UNITED STATES PATENT AND TRADEMARK OFFICE

APPLICATION NO.	FILING DATE	FIRST NAMED INVENTOR	ATTORNEY DOCKET NO.	CONFIRMATION NO.
09/655,191	09/05/2000	Takayasu Komatsu	TJK/115	7754

# Office Action Summary

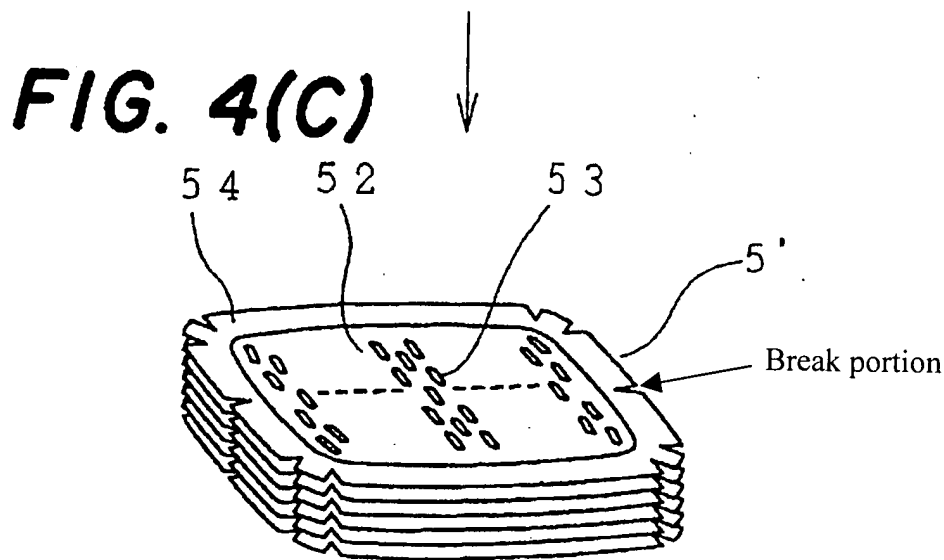
16. In regards to claims 1 and 5, Hosotani discloses in figures 4a-4d, a shadow mask formed from a plate member comprising an outer frame portion (1), a body portion of a shadow mask having an outer peripheral line (54) which is patterned by means of photography (column 2 lines 23-25). Hosotani further discloses a break portion (see below) which is recessed inward from the outer peripheral line of the shadow mask.

28. Hosotani further teaches in figure 4c that the portion to be broken is arranged so as to be opposed to the connection portion. Hosotani further teaches the portion to be broken has a predetermined length in a direction along the outer peripheral line. Hosotani further teaches in figure 4c that the portion to be broken is a portion forming a break portion of the shadow mask from which the outer frame portion is removed.
